Item #17  
MCPB  
9/5/03

**MEMORANDUM**

**REVIEW TYPE:** Site Plan Review  
**APPLYING FOR:** Approval of 32 townhouses on 6.22 acres  
**PROJECT NAME:** Fraley Property  
**CASE #:** 8-03030  
**REVIEW BASIS:** Div. 59-D-3, Montgomery County Zoning Ordinance for Site Plan

**Fralley Property  
 2025 Noise Contours**

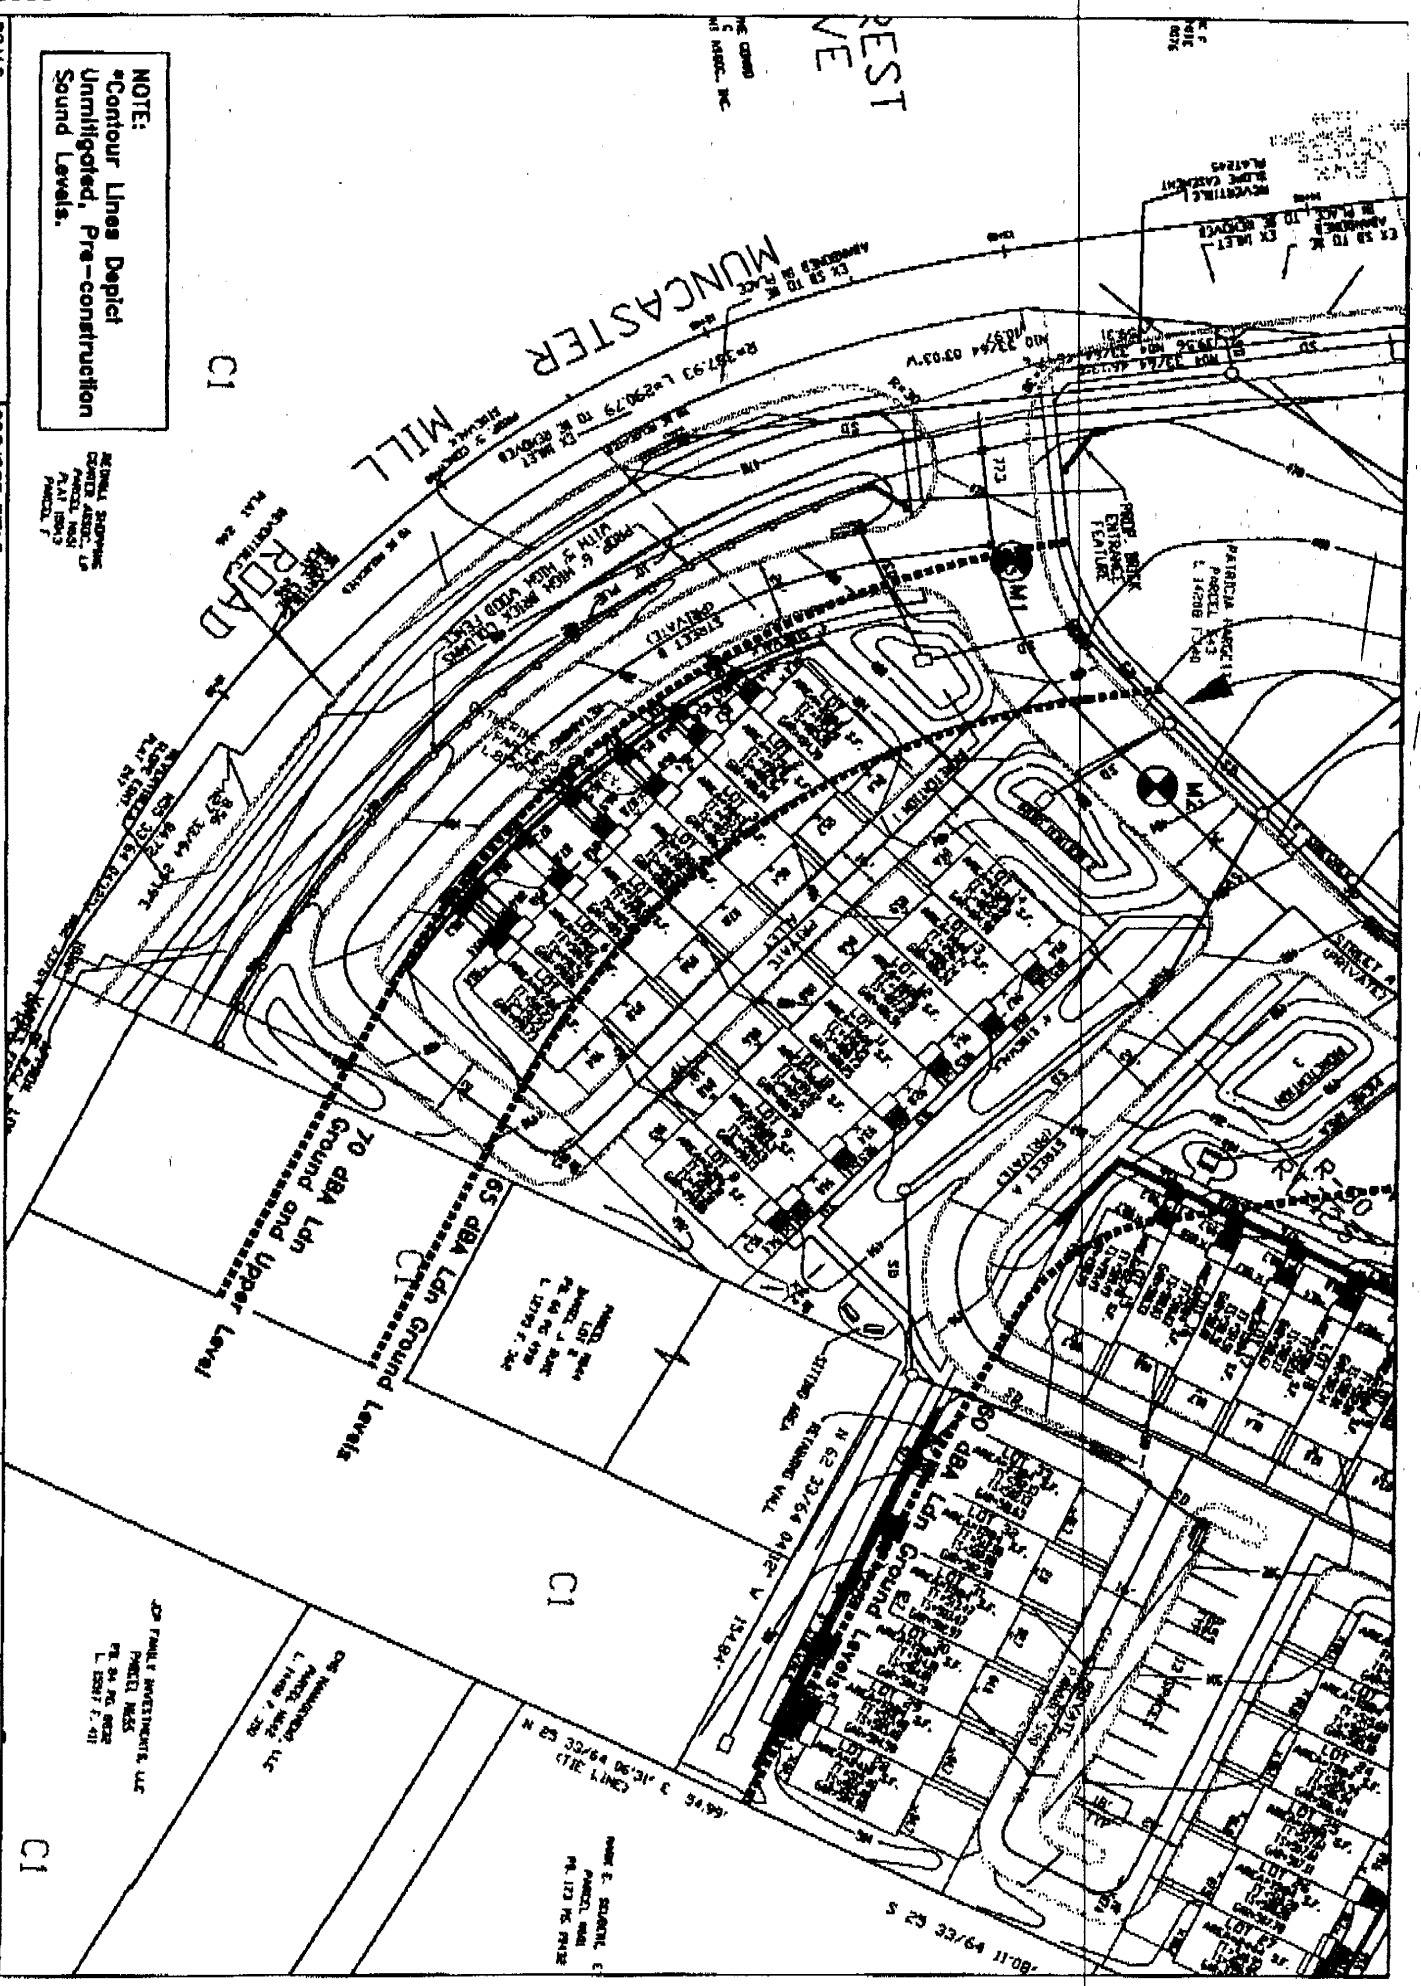
Noise contours for the site indicate the front units along Muncaster Mill Road and 4 rear yards are above 65 dba and mitigation is required. Architectural controls and internal sound walls (at the end of units) are proposed.

From our traffic noise analysis, proposed rear deck areas of Lots 1-14 will lie within the future unmitigated 60 and 70 dBA  $L_{dn}$  contours from Muncaster Mill Road. Montgomery County noise code requires noise levels in residential outdoor activity areas, such as decks, to not exceed 60 dBA  $L_{dn}$ . Utilizing elevation information from the architectural drawings, a barrier analysis was performed to determine the mitigation impact from the front row of townhomes (Lots 1-7) on 2<sup>nd</sup> floor rear deck areas. The mitigation for these townhomes, modeled as a 30-foot high barrier relative to ground height, was calculated using the HUD Noise Guidebook Methodology. Results indicate that a minimum of 4 to 4.5 dBA of noise mitigation for the rear decks of Lots 2-7 and 9-13 can be gained from the townhomes, reducing noise levels below the 60 dBA  $L_{dn}$  criterion. The HUD Worksheets for these calculations are enclosed.

- a. Certification from an acoustical engineer that the building shell of impacted buildings has been designed to attenuate projected exterior noise levels to an interior level not to exceed 45 dBA Ldn. The builder commits to construct these units in accordance with the acoustical specifications identified in the August 29, 2003 noise analysis. Any changes that may affect acoustical performance must be approved by the acoustical engineer and reviewed by staff in advance of installation.

Frale Property  
 NOISE WALL  
 UP TO 8' HIGH

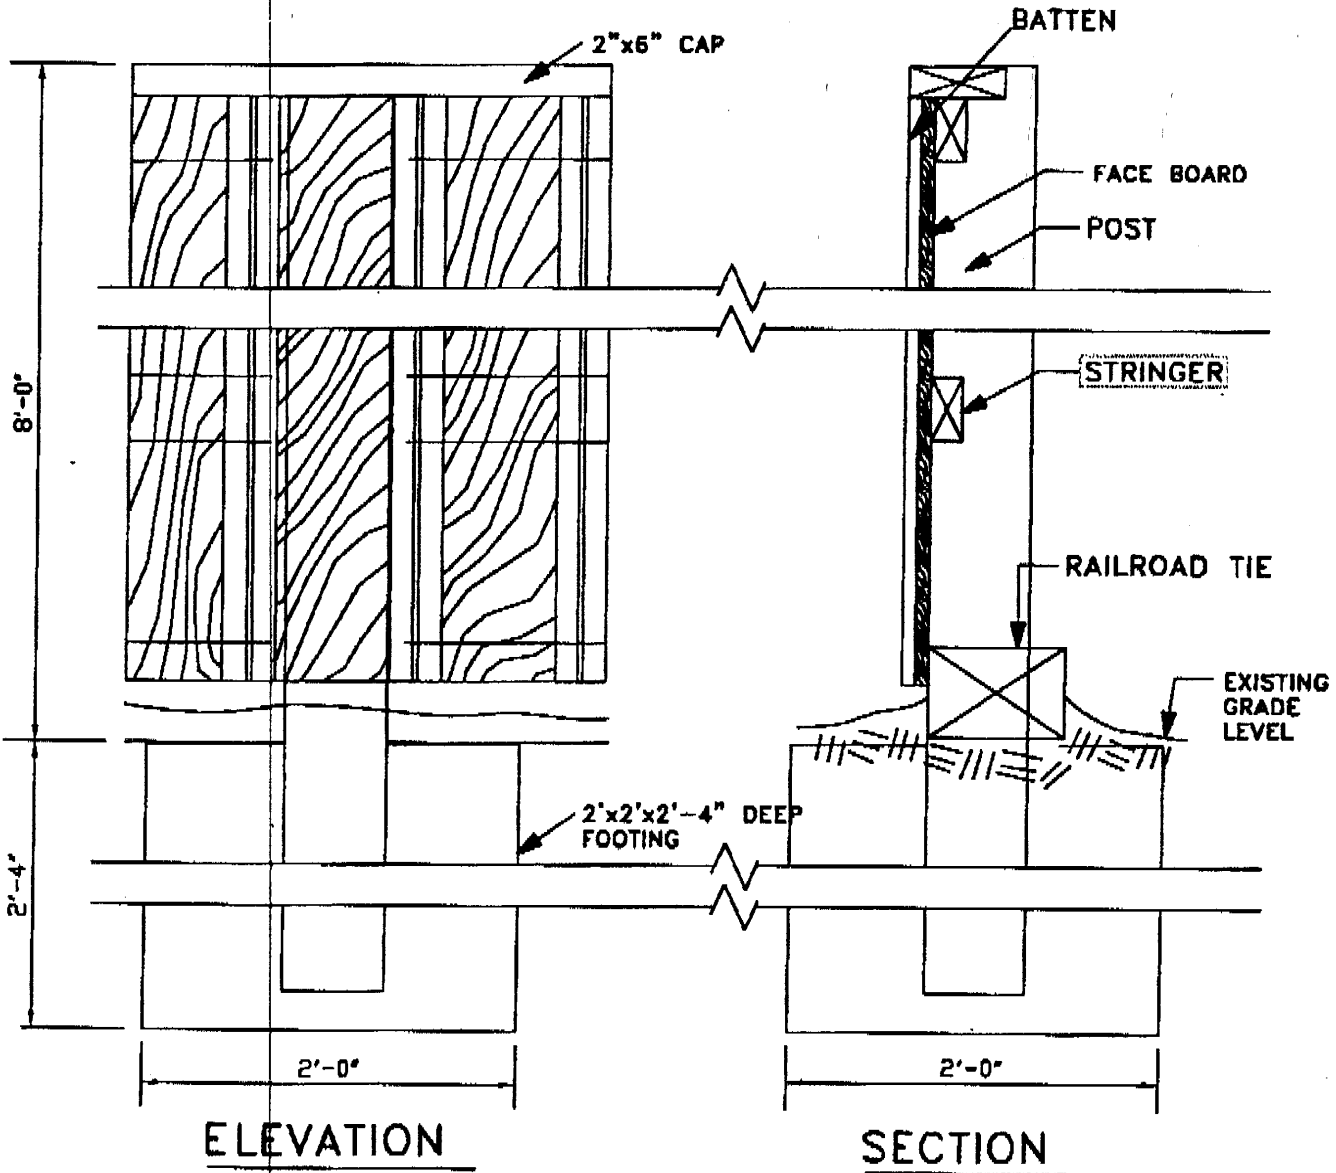
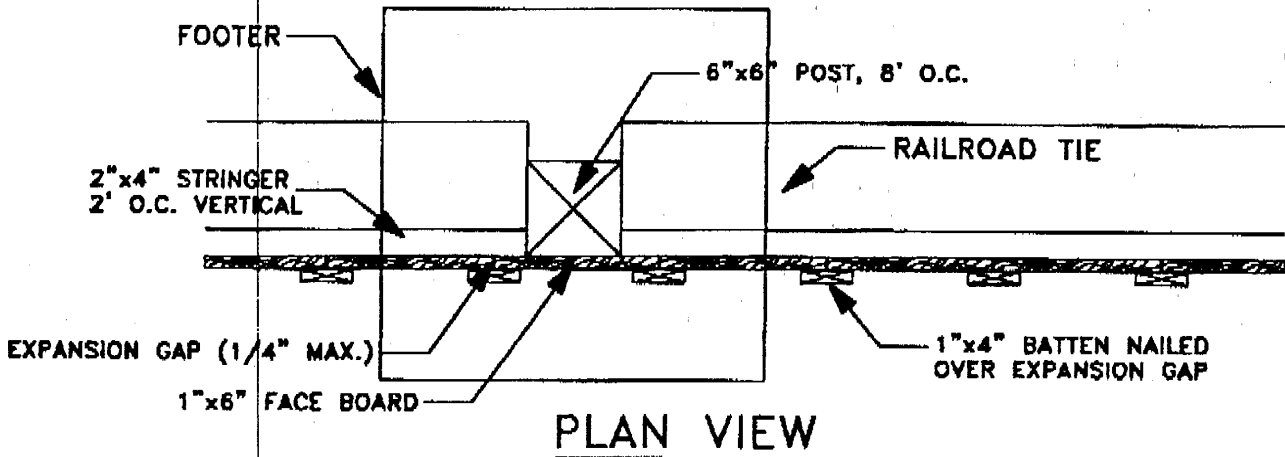
Due to the locations of Lots 1, 8, and 14, the rear decks of these lots do not receive the full benefits of the shielding offered by the townhomes. However, the rear deck of Lot 8 will receive mitigation from surrounding buildings, aiding in the reduction of noise levels in this area. With this mitigation and because Lot 8 has an unmitigated noise level of 63.5 dBA  $L_{dn}$ , with minimal exposure to the roadway, no steps to further mitigate noise is recommended. The implementation of noise mitigating side screens is suggested for Lots 1 and 14 because of their exposure to roadway noise. These screens are wood barriers constructed of nominal 1-inch thick boards with no gaps or openings.
